ORDER NO. MD0512456S1

Service Manual

SA-AK333P

Top Cabinet change (Additional Information)

2.1. Cabinet Parts Location (Additional Information)

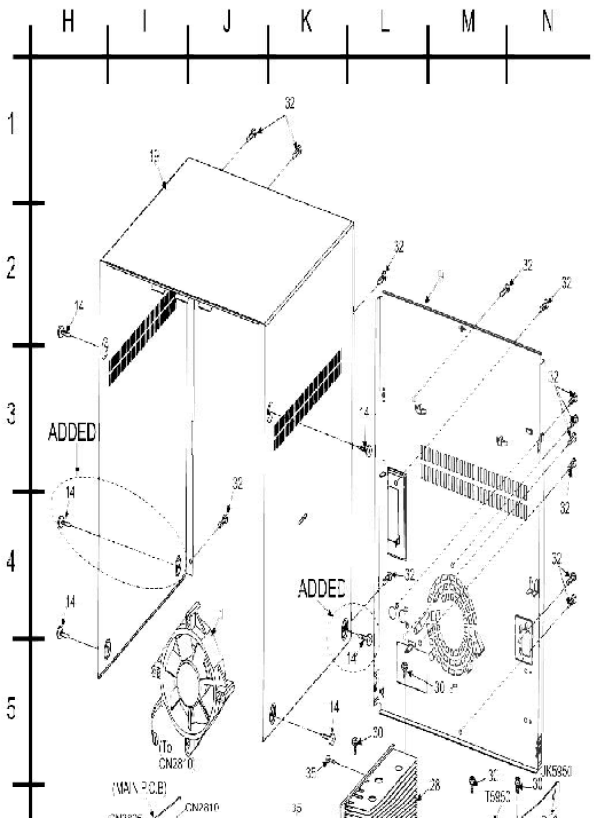
During the replacement of the top cabinet for the mentioned models, the below rules of compatibility (Table 1) must be followed & parts must be replaced correctly. This is mainly due to top cabinet specification change (additional of one screw hole) for improvements.

With reference to page 97 (section 23.3.1) of the original service manual for SA-AK333P-S. The cabinet parts location below is for the new implementation.

- When replacing the new top cabinet, ensure that the NEW bottom

chassis must also be changed together at the same time (Refer to Table 1).

- Do not interchange the parts.

Ref. No.	Part No.	Part Name & Description	Remarks
		CABINET AND CHASSIS	
19	RKMX0105-S1	TOP CABINET	[M]
